# Westbury-sub-Mendip Parish Council

# Westbury-sub-Mendip: Proposed Development at Roughmoor Lane: Highways Scoping Report

Project Roughmoor Lane, Westbury-Sub-Mendip

Drawing Composite Masterplan

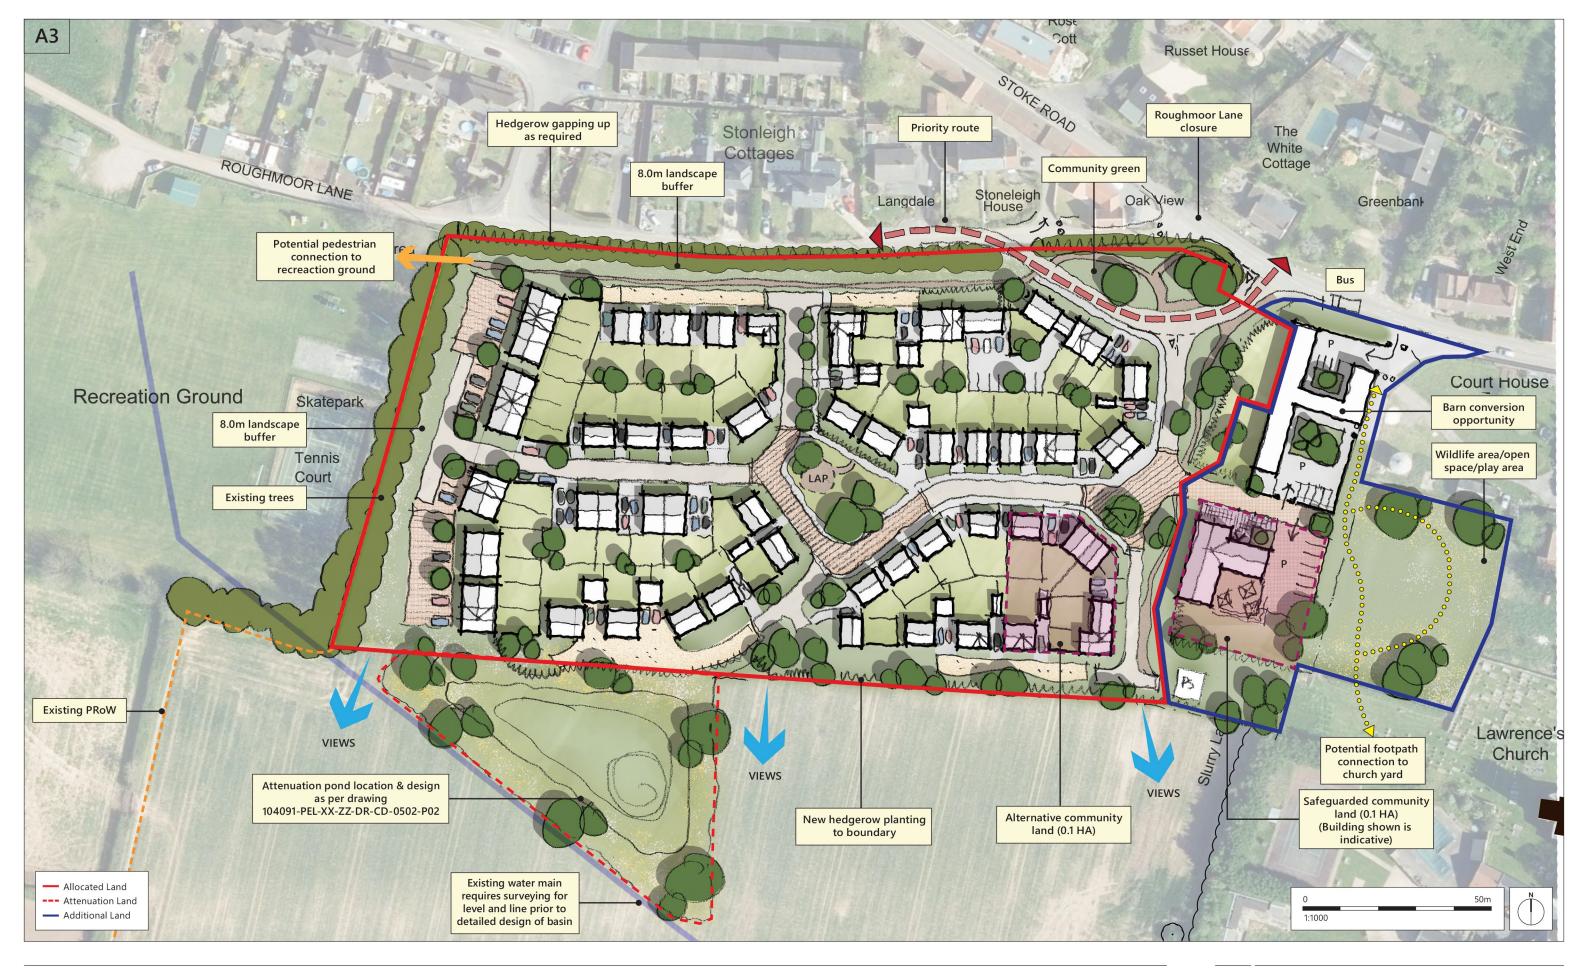
Drawing CMP.01, Composite Masterplan has been prepared for the Church Commissioners of England by Thrive Architects and is attached to this report. It is recognised that this is a preliminary document. This shows a realignment of Roughmoor Lane to a new junction with Stoke Road east of its existing junction with Stoke Road. An access to the proposed development site is shown from the realigned Roughmoor Lane.

a priority junction of the realigned Roughmoor Lane with Stoke Road; a mini-roundabout junction of the realigned Roughmoor Lane with Stoke Road;

a mini-roundabout junction of Stoke Road, Wells Road and School Hill; a non-ghost island junction of Stoke Road, Wells Road and School Hill by realigning the southern kerbline northward; explore traffic calming facilities to limit speeds to 20 miles per hour between Roughmoor Lane and Station Road.

explore various pedestrian crossing facilities on Stoke Road to suit trips between the proposal site and the village core;

show replacement parking for that lost at Mortar Pits;

show replacement bus stop facility;

give-way/priority outbound gateways at each end of the village

show safe pedestrian links between existing development on Roughmoor Lane and the village core

show how land in the control of the applicant might be used to improve traffic movements along the retained part of Roughmoor Lane.
